PROJECT: TTU TRACK AND FIELD
SBC# 364/011-05-2025
BAA Project Number 25007
Cookeville, Putnam County, Tennessee

SUBJECT: Addendum No 1

- 01 SITE PLAN
SITE - FIRST LEVEL

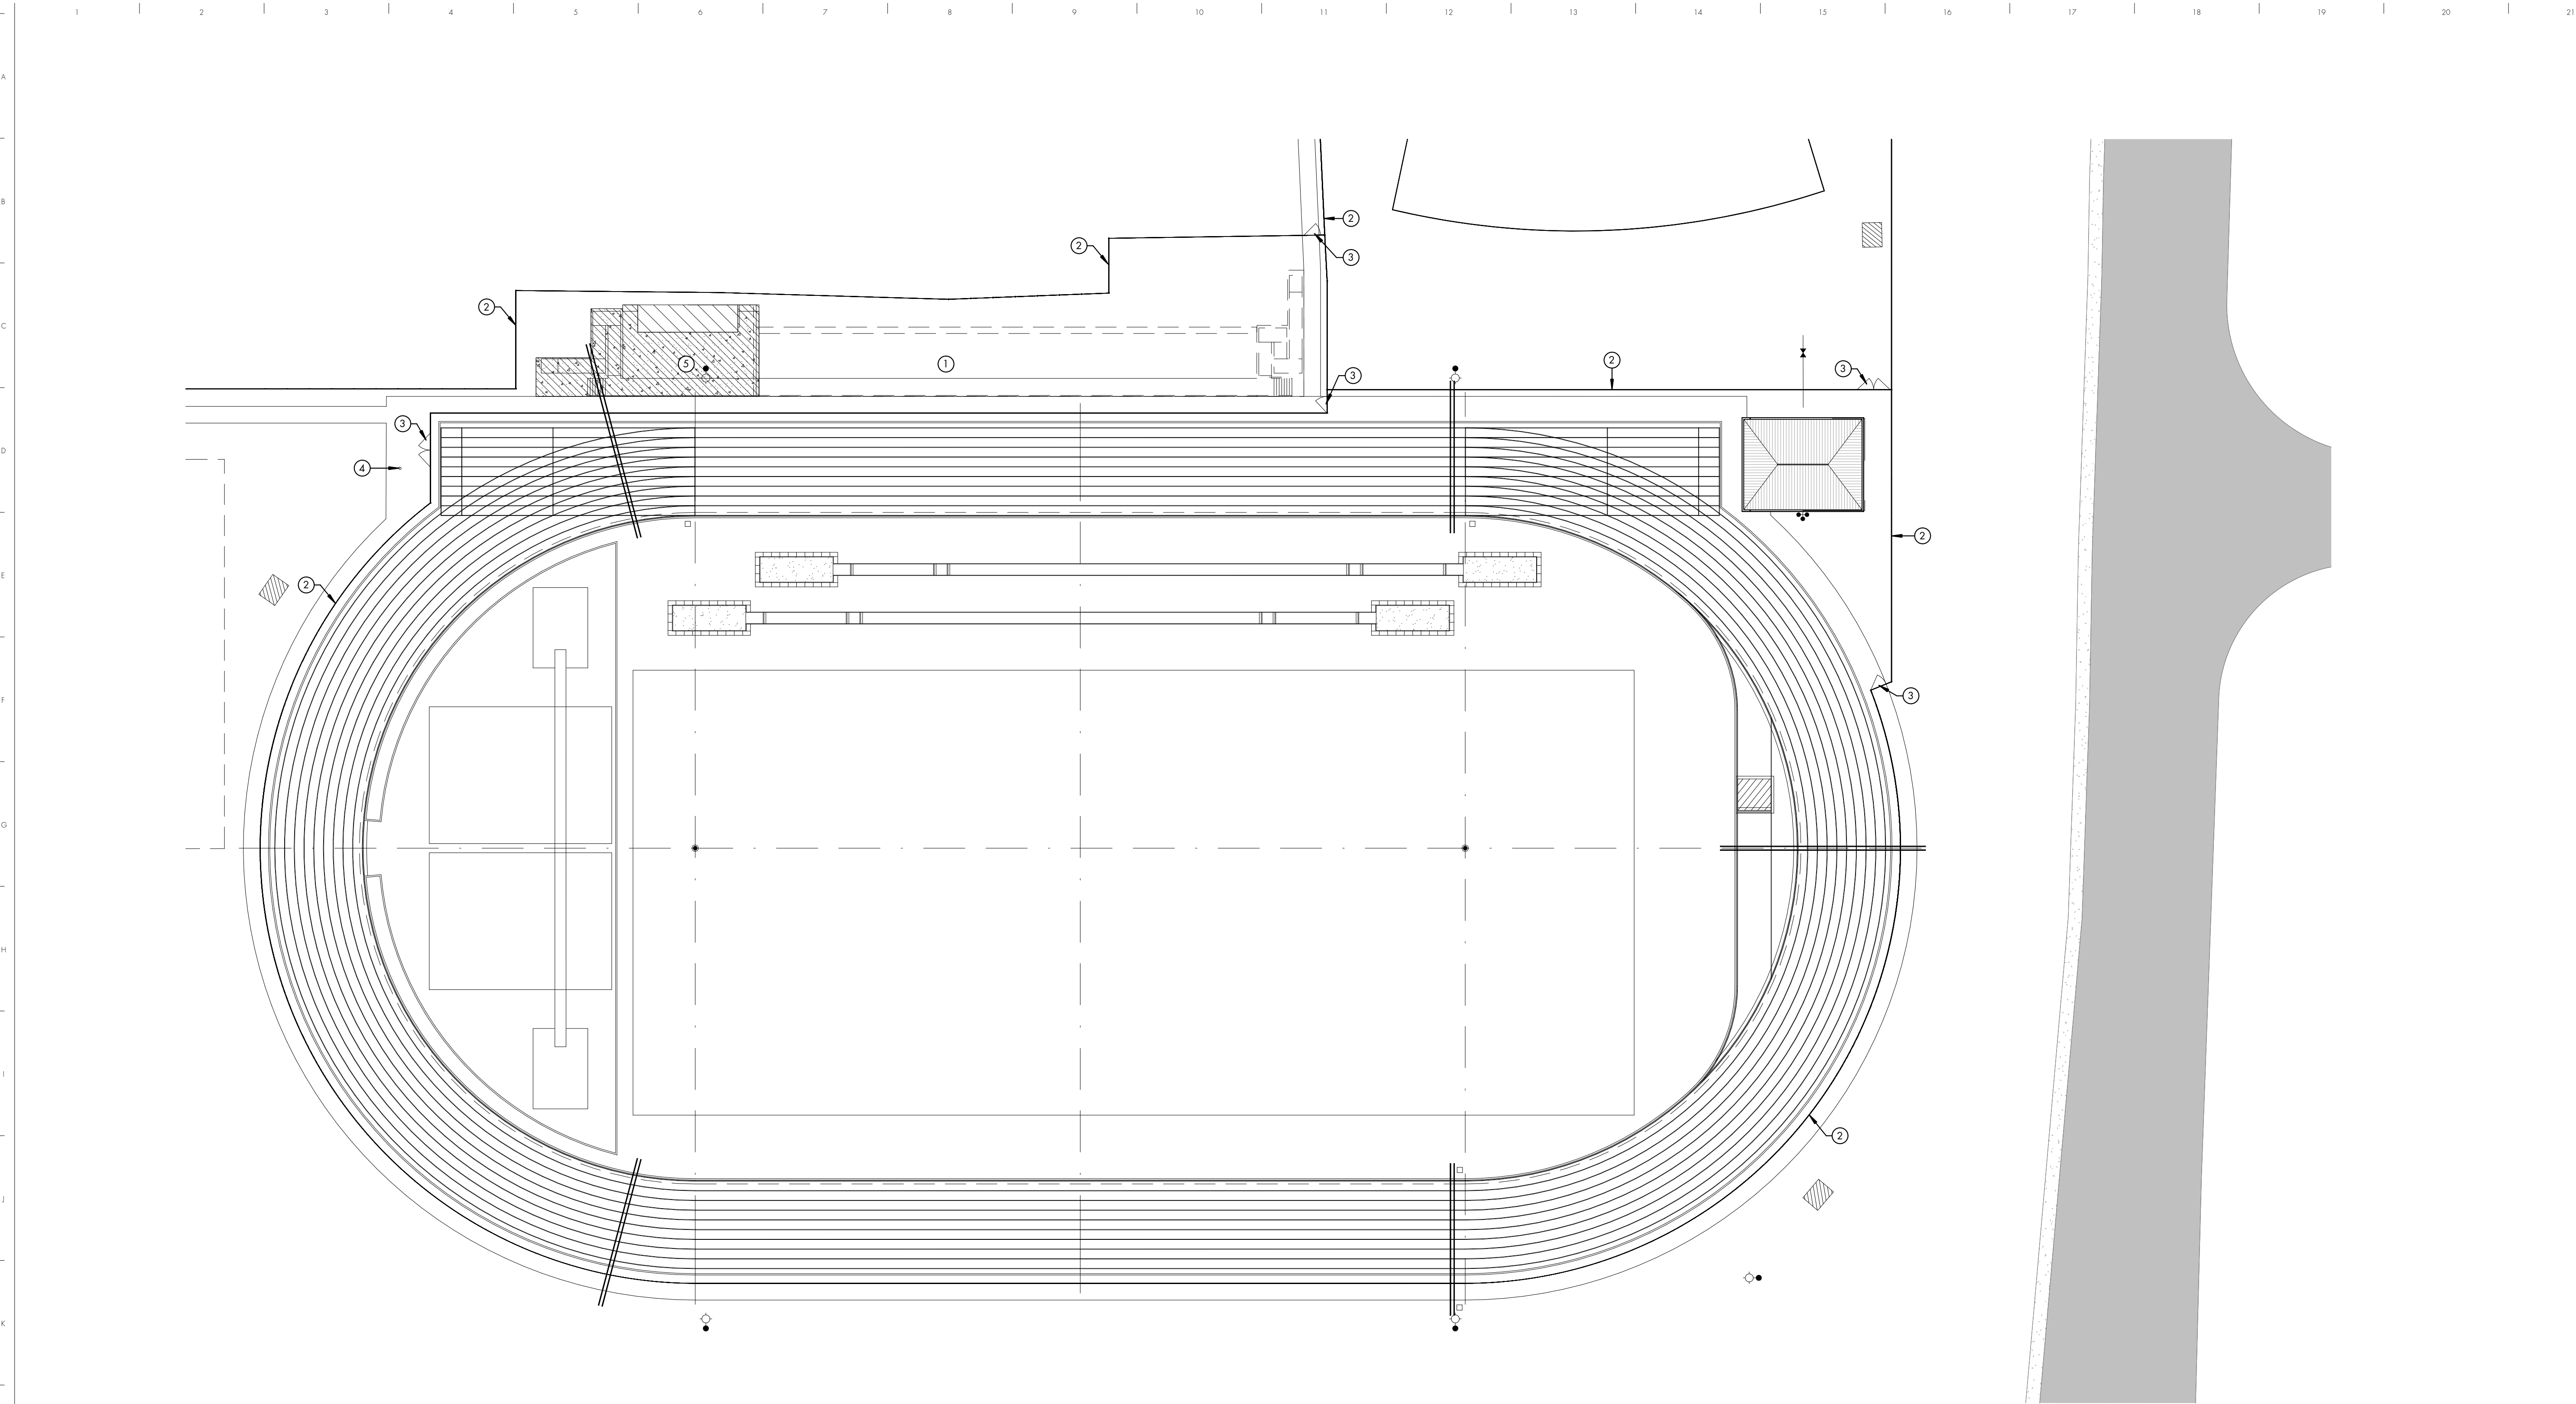
46. Question: The graphic scale on AS.01 is incorrect. What is the correct scale?
Answer: The graphic scale was updated for Detail 01/AS.01 in Addendum No. 1.

- 01 FLOOR PLAN
CALLOUT

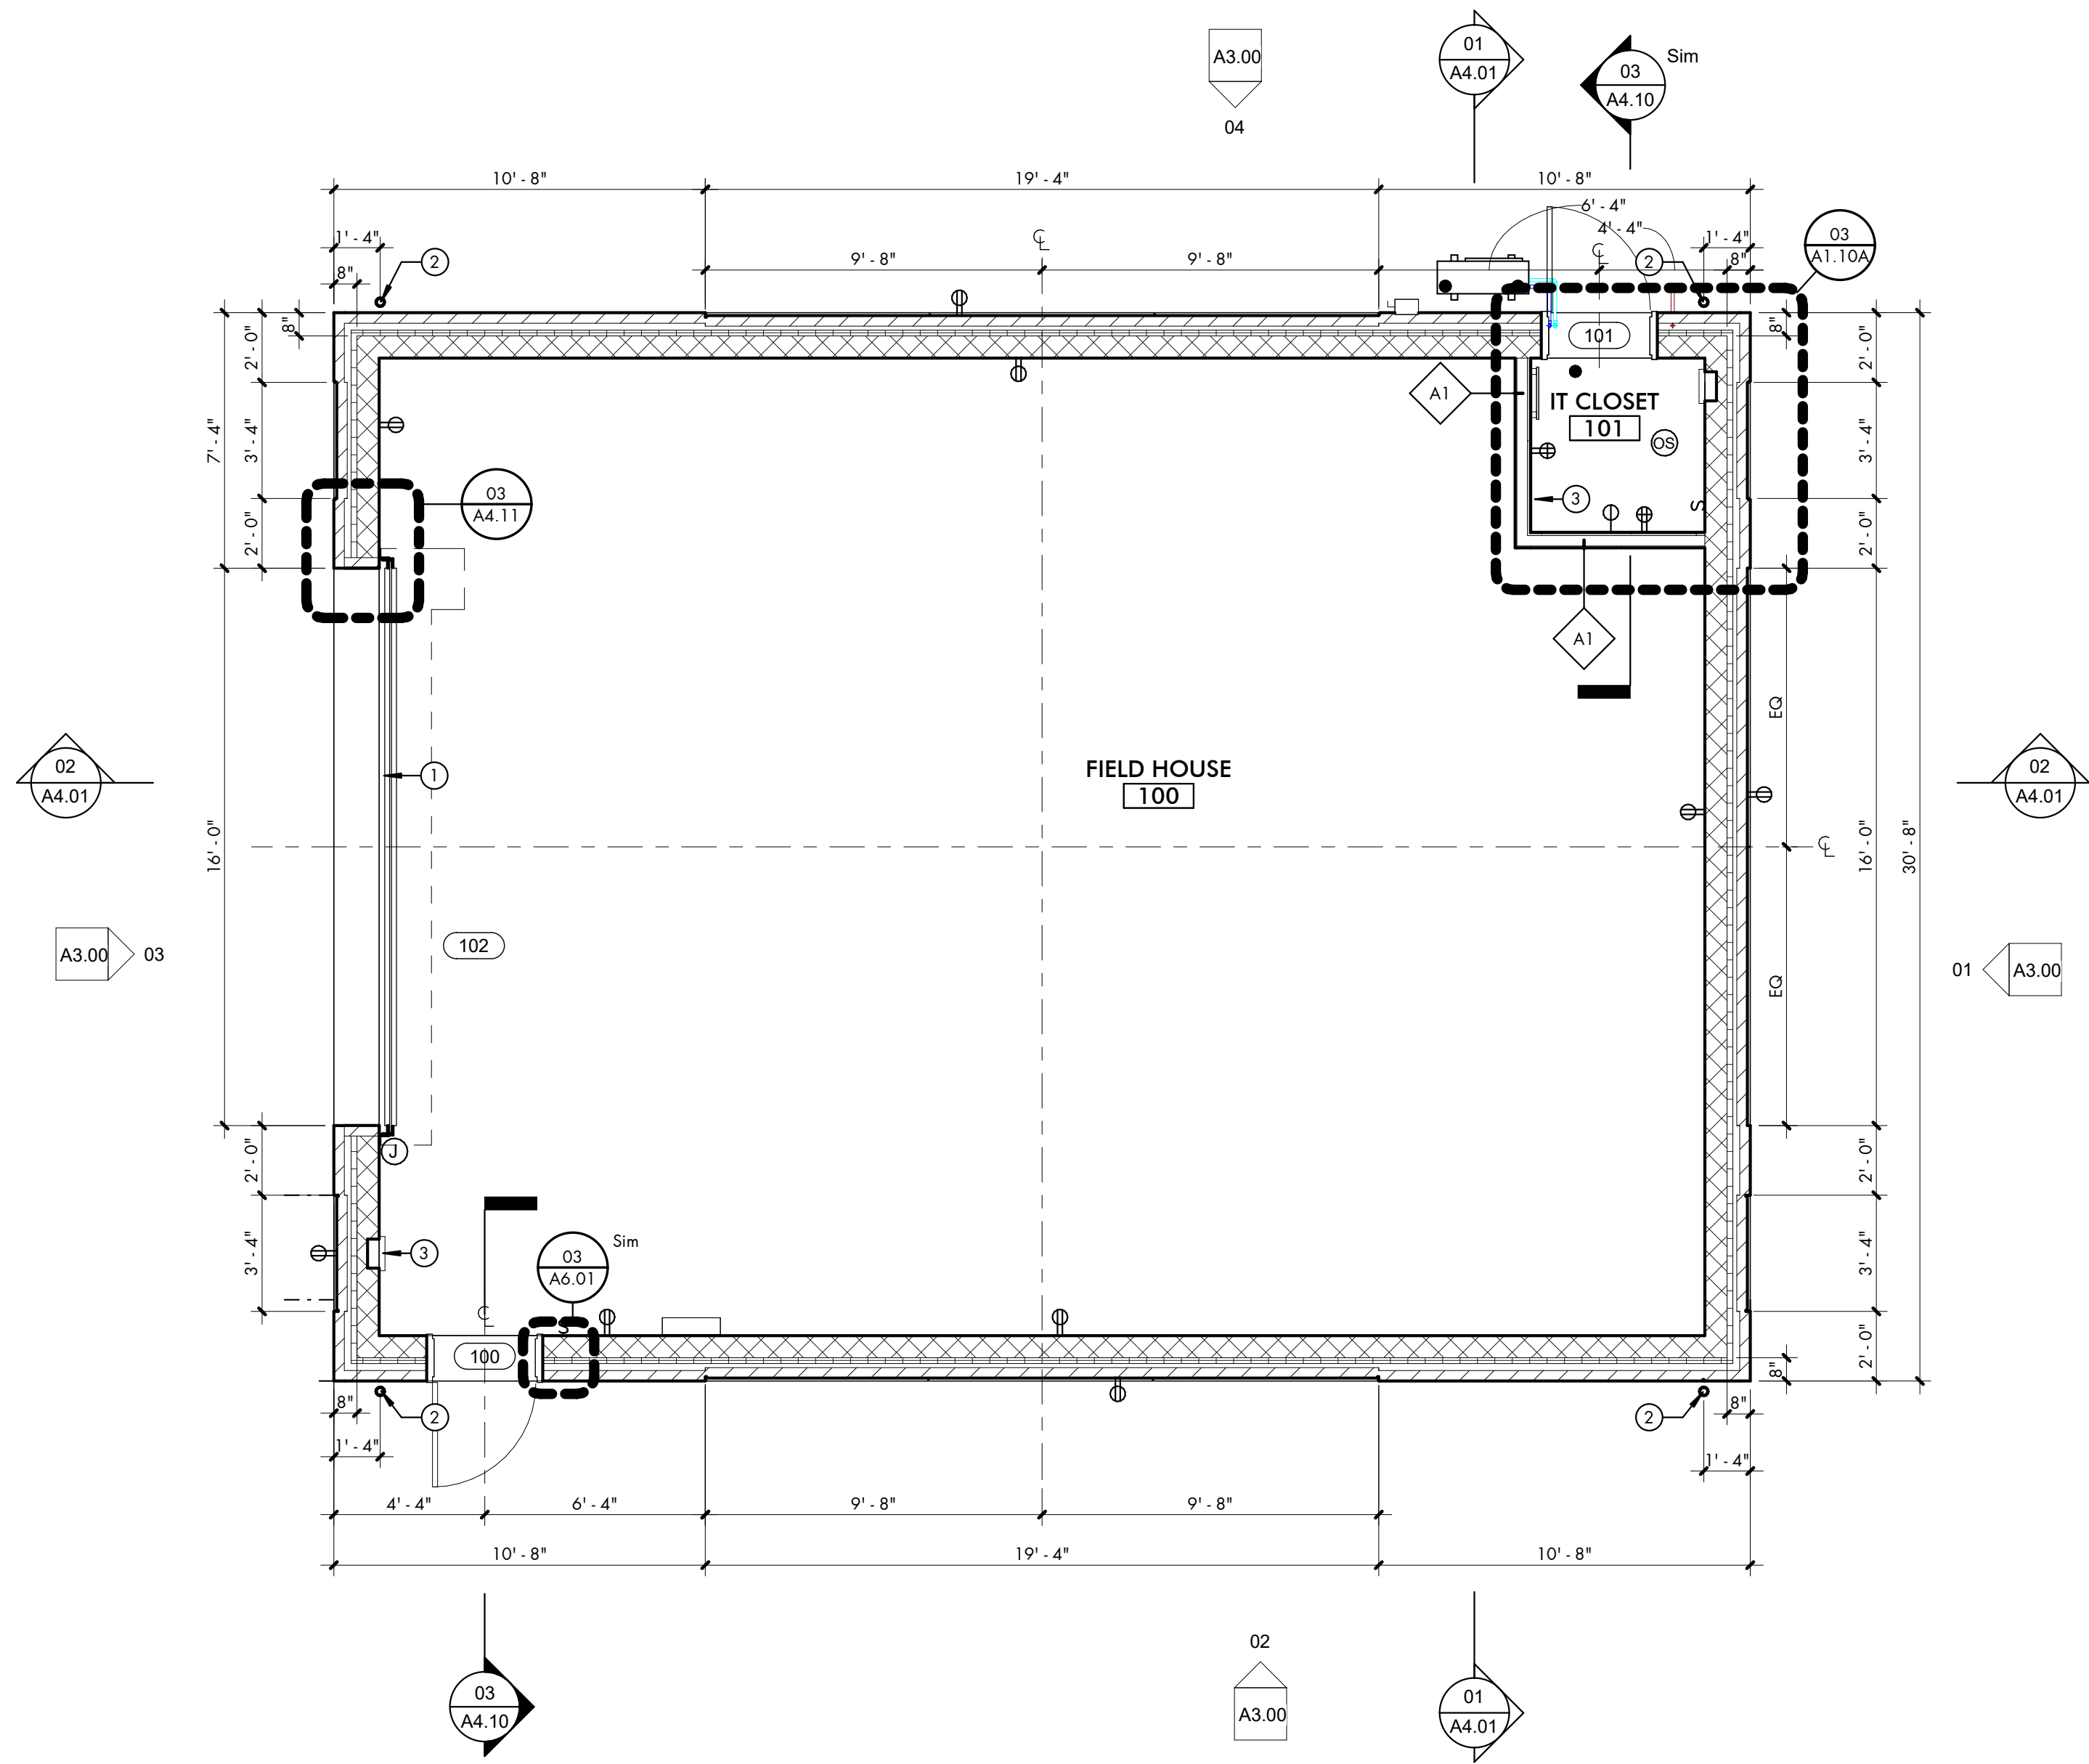
47. Question: The graphic scale for the enlarged IT Closet plan on A1.10A is incorrect. What is the correct scale?
Answer: The graphic scale was updated for Detail 03/A1.10A in Addendum No. 1.
